Tallaght / Clondalkin to City Centre Core Bus Corridor Scheme

NTA Observations on the Proposed Scheme CPO Objections

September 2023

Figure 2.10.1: Location of new links included in the Proposed Scheme in the vicinity of Calmount Business Park

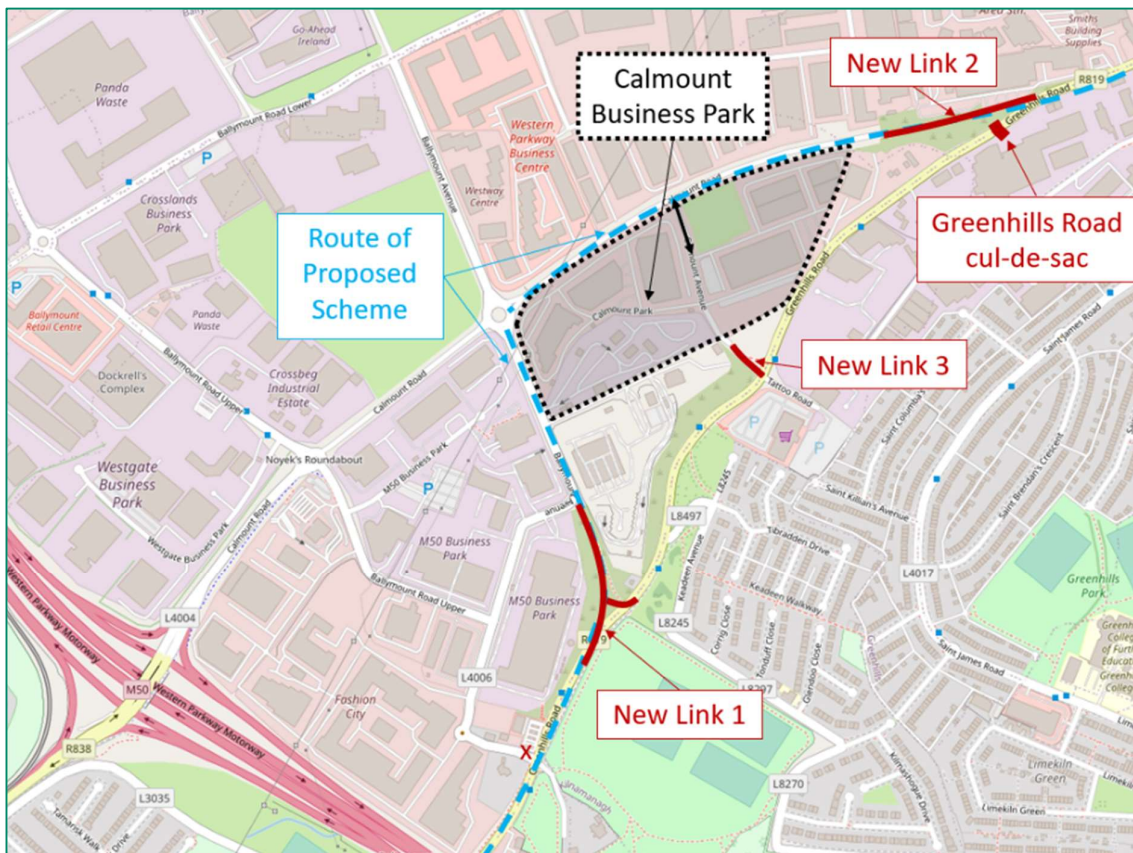
The existing Ballymount Road Upper connection to Greenhills Road will be closed to vehicular traffic and a new 220m long link road to the south of Ballymount Avenue will provide a connection to Greenhills Road (R819), new link 1 in Figure 2.10.1. New boundary walls / fencing and earth embankments will be required at this location to facilitate the new road construction. It is proposed to widen the existing Ballymount Avenue and Calmount Road for dedicated bus and cycle tracks and connect Calmount Road to Greenhills Road.

The existing Greenhills Road (R819) will be retained for local access and cycling facilities with a cul-de-sac treatment to the northern end where a new approximately 250m long sustainable transport link road will be constructed in the green area to the east of Calmount Road, new link 2 in Figure 2.10.1. New retaining walls and earth embankments will be required at this location to facilitate the new road construction.

In addition, a third new link road is proposed to maintain access for local businesses along the Greenhills Road (R819) and in this area a small roundabout will be constructed with a new link road approximately 90m in length to connect Greenhills Road with Calmount Avenue. This is shown as new link 3 in Figure 2.10.1, which generally aligns to the principles of the SDCC Part 8 schemes for the area. Accessible ramps and stairs will be provided to mitigate against the steep gradient on Calmount Avenue where it joins to Greenhills Road.
